## **BURTON-PATE INDUSTRIAL PARK SUBDIVISION,** **RESUBDIVISION OF LOTS 1 AND 2**

APPLICATION NUMBER 15 DATE December 6, 2012  
 APPLICANT Burton-Pate Industrial Park Subdivision, Resubdivision of Lots 1 and 2  
 REQUEST Subdivision

# DETAIL SITE PLAN

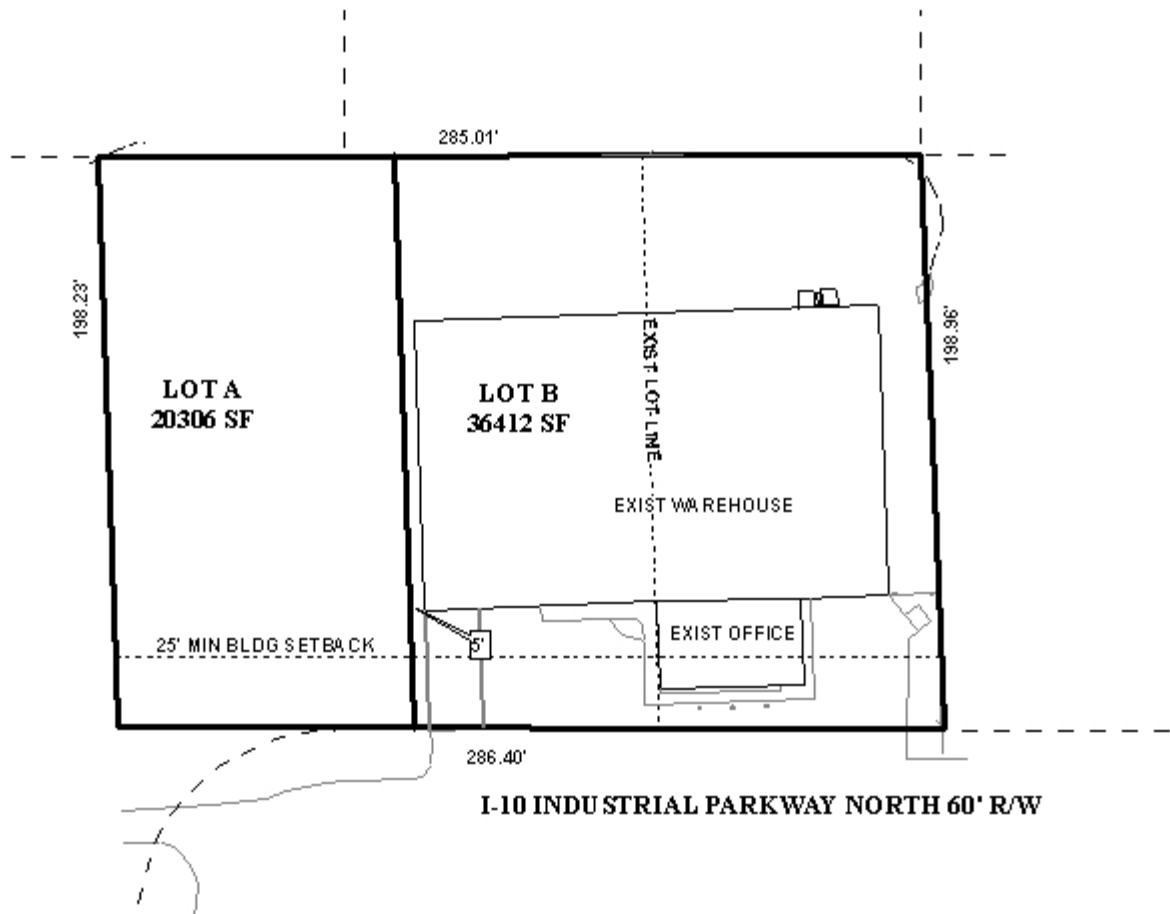
The lot sizes are labeled, and the proposed lots would exceed the minimum size requirements of Section V.D.2. of the Subdivision Regulations. The lot sizes should be retained in square feet and acres on the Final Plat, as on the preliminary plat, if approved.

The site fronts onto I-10 Industrial Parkway North, a minor street with no curb and gutter. The preliminary plat illustrates a compliant 60' right-of-way making no dedications necessary.

The 25-foot minimum building setback line, required in Section V.D.9., is illustrated and labeled along all frontages on the preliminary plat. If approved, the 25-foot building setback line should be retained on the Final Plat. There is a portion of an existing office located in the required front setback, however because the encroachment is existing, and no new construction is proposed at that time, it is considered a legal non-conforming structure. It should be noted however that any future construction must comply with setback requirements.

As a means of access management, a note should be placed on the Final Plat, if approved, stating that Lot A is limited to one curb cut to I-10 Industrial Parkway North, and Lot B is limited to existing curb cuts to I-10 Industrial Parkway North, with the size, location and design to be approved by Traffic Engineering and conform to AASHTO standards. It should also be noted that the preliminary plat incorrectly labels the street as "I-10 Industriall Parkway North". If approved, the street name should be revised to be spelled correctly.

- 1) illustration of the 25' minimum building setback line;
- 2) labeling of the lot size in square feet and acres;
- 3) revision of the street name to correctly read "I-10 Industrial Parkway North";
